Appendix 15 - Noise Technical Note

**Applicant Statement of Case - Appendices
CROWN/2025/000002 Sevington Inland Border Facility**

Technical Note – Noise Statement of Matters

Document Reference: 20980119-WAT-ENV-XX-TN-N-710001_C02_A0

Aerial Image 1: IBF Sevington & Ashford International Lorry Park

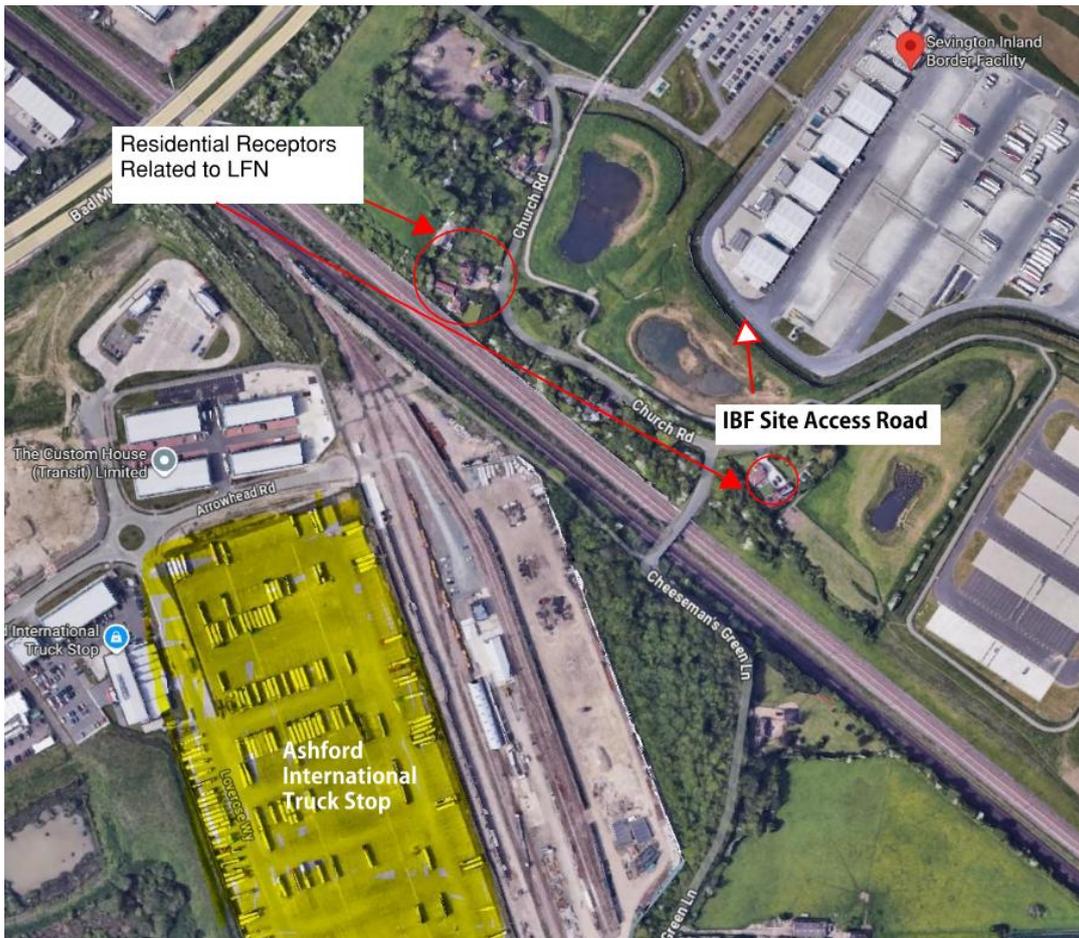
- 9.5. **The concerns raised by the resident [REDACTED] and conduct additional investigation to the reported low frequency noise from HGVs, tonal noise from refrigerated HGV's, reversing beepers, clanging of curtain sider poles and horns in their analysis of the recorded data in their response.**

- 9.12. *Mott MacDonald’s Technical Note stated the presence of LFN at 40Hz (1/3 octave centre band frequency). It is noted that the residential properties in question are in close*

proximity to the high speed railway line H1 (approximately 35m), which are known for their high spectrum content of low and mid frequency noise due to aerodynamic and wheel/rail interaction noise. It is appreciated that there is a rail acoustic barrier to protect residential properties on Church Lane from high speed H1 rail noise, which is understood to be a timber structure 4.5m high⁴. In addition to this there are a number of other off-site industrial sources immediately south of the railway lines which could also be potential sources of LFN such as Network Rail Sevington Sidings Works, approximately 90m and Ashford International Truck Stop, approximately 155m. In comparison the IBF site exit road is approximately 155m from the nearest residential property on Church Road, which also has a timber acoustic barrier. It should be noted that noise from Ashford International Truck Stop will be a similarly sound to that from IBF Sevington, both having moving and potentially idling HGVs. Refer to Aerial Image 1.

Histogram 7: Orchard Cottage – Internal Noise Levels In Living Room (Feb 2022)

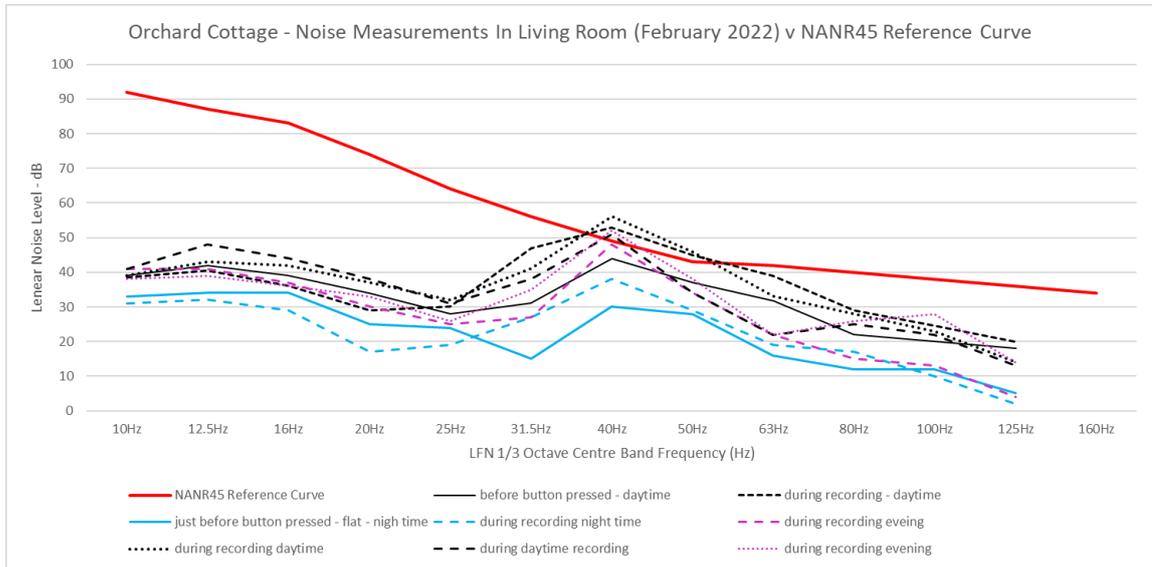
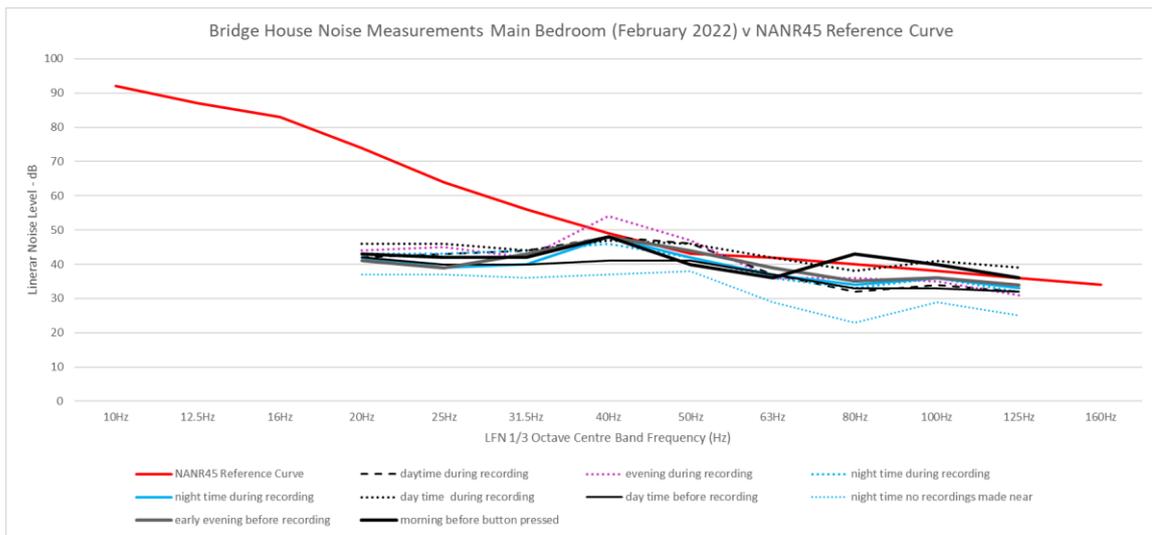
- 9.38. **General noise, tonal noise (humming, repeated sounding of horns, reversing sounders) and Low Frequency Noise (LFN) have been reported with some residents suffering impact to health and disturbed sleep. The complaints were supported by the local EHO following noise monitoring in two dwellings near the site.**

- 9.17. *Histogram 3 presents the measured internal noise levels in February 2022 in the living room of Orchard Cottage and Histogram 4 presents the same but in the main bedroom of Bridge House. It is assumed that the noise measurements were conducted by Ashford Borough Council (ABC) as they were sent by email from ABC to Defra dated 17th February 2022, therefore predating Mott MacDonald’s investigation of IBF Sevington LFN. The description of the measurement sets does however indicate they were undertaken in an unoccupied room and therefore could potentially be contaminated. Also, the noise event measurements may be of a source not associated with IBF Sevington. Both Histograms also include the NANR45 LFN reference curve. Where noise levels exceed the NANR45 LFN reference curve the document states “it may indicate a source of LFN that could cause disturbance.” The assumption is that Mott MacDonald were provided this information which formed part of their investigation.*

9.18. *At face value, notwithstanding potential contamination or source not being IBF operational noise, daytime recordings within Orchard Cottage living room illustrate exceedance of the NANR45 LFN reference curve at 40Hz and 50Hz, with slight exceedance during one evening measurement at 40Hz. No exceedance of the NANR45 LFN reference curve is illustrated during the nighttime event measurements. Within Bridge House main bedroom, Histogram 4 illustrates exceedance of the NANR45 LFN reference curve at 40Hz during one evening measurement period. Exceedance at 50Hz is also evident during one evening and daytime period with another exceedance at 100Hz. There are no*

exceedances during the nighttime period, although at 40Hz it is at the NANR45 LFN reference curve.

- 9.41. *With regard to the comment on LFN and noise monitoring in two dwellings, if this is the noise monitoring that was conducted within a living room at Orchard Cottage and main bedroom of Bridge House in 2022, then the results indicate that the NANR45 reference curve for LFN is not exceeded during the nighttime period. This would be indicative that LFN during the nighttime period does not result in health impacts or disturbed sleep, although it is appreciated and as reflected in NANR45 that “LFN is known to occur at levels only slightly higher than hearing threshold, which varies from one individual to the next.” So LFN sound could appear loud to one person yet inaudible to another. It should also be borne in mind that exceedance of the NANR45 LFN reference curve is not a prescriptive indicator of nuisance. The NANR45 document also highlights that people can also become ‘sensitised’ to LFN.*
